Clarifications No. 01 Dated 02.12.2019 to Bid Queries

NIB No. 343 Dated 20.11.2019.

Name of work: Limited Tender for undertaking "Industrial All Risk (IAR) Insurance Policy for the Assets of Tripura Gas Based Power Plant (101 MW), Monarchak, Tripura for a period of 1(one) year w.e.f. 00:00:00 Hours of 23.12.2019".

PACKAGE	FIRE PROTECTION SYSTEM
TITLE	COMPOSITE PIPING LAYOUT OF HYDRANT & SPRAY SYSTEM
DRG. NO.	TSPL-P220-LAY-104
SCALE	SCALE=1:800
SHEET NO.	1 OF 1
REV.	1

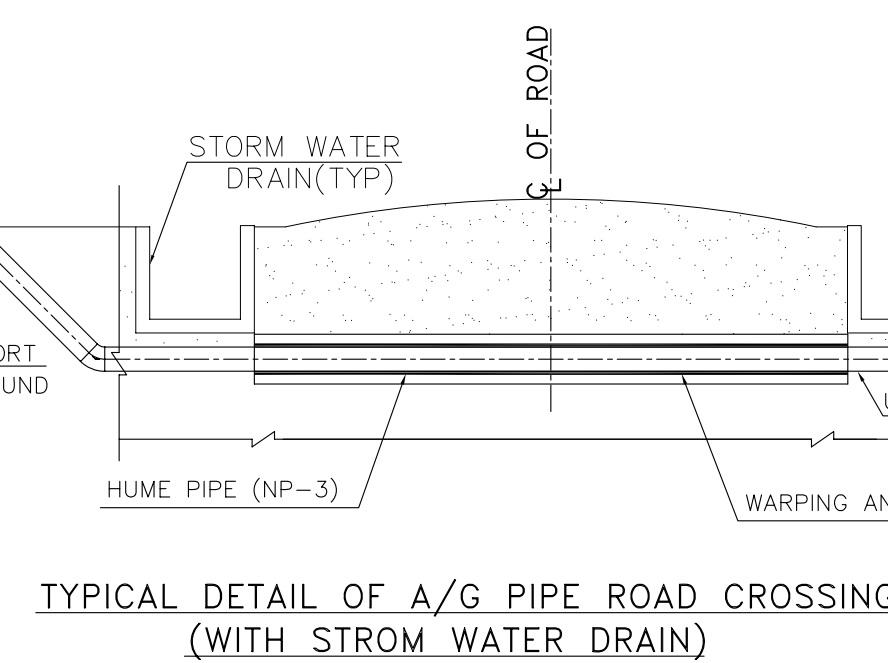
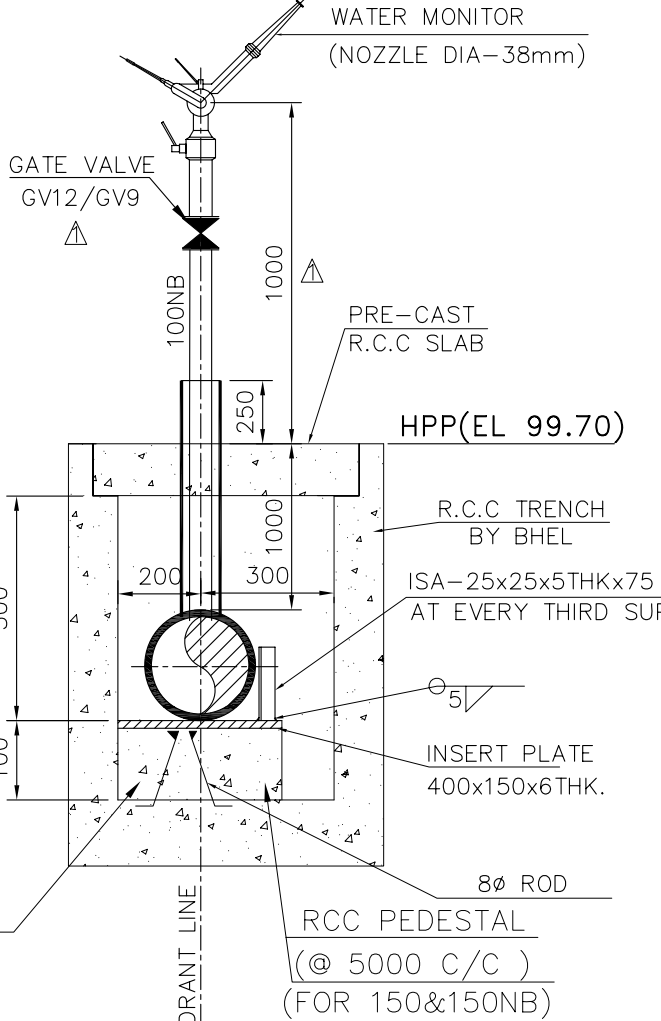
Sl. No.	Bidders Queries	NEEPCO's Response
1.	Bidders have requested to provide schematic diagram of Project layout and its accessibility.	The salient feature of the project is available in NEEPCO Website www.neepco.co.in . The plant layout is enclosed as Annexure-A .
